ECR #: P6

Title: Correction for Key to Pin 1 Measurement in Figures B2 and B3

Spec Version: NLX 1.2

Figure B2: NLX Riser Example 1

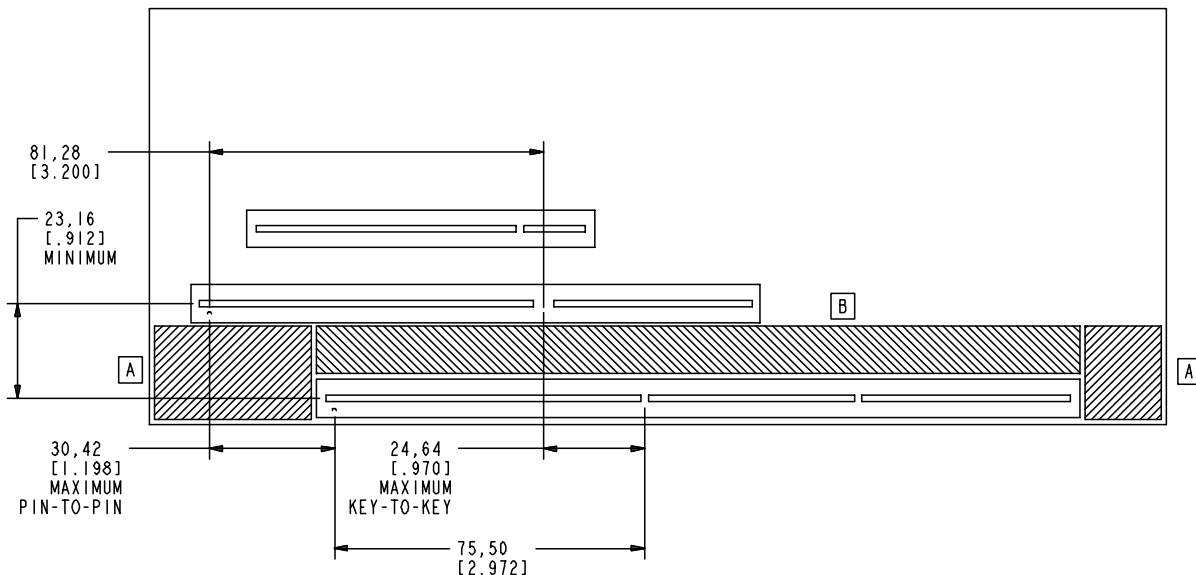
In Figures B2 and B3, the measurement from the key on the NLX riser connector to pin 1 on the connector needs to be corrected from 77.44 [3.049] to 75.50 [2.972].

On the NLX riser connector, as shown in Figures B2 and B3, the measurement from the key on the connector to pin 1 erroneously shows this as 77.44 [3.049]. The actual measurement is 75.50 [2.972]. The figures need to be replaced with the new figures below.

Replace Figure B2, NLX Riser Example 1, with the following figure:
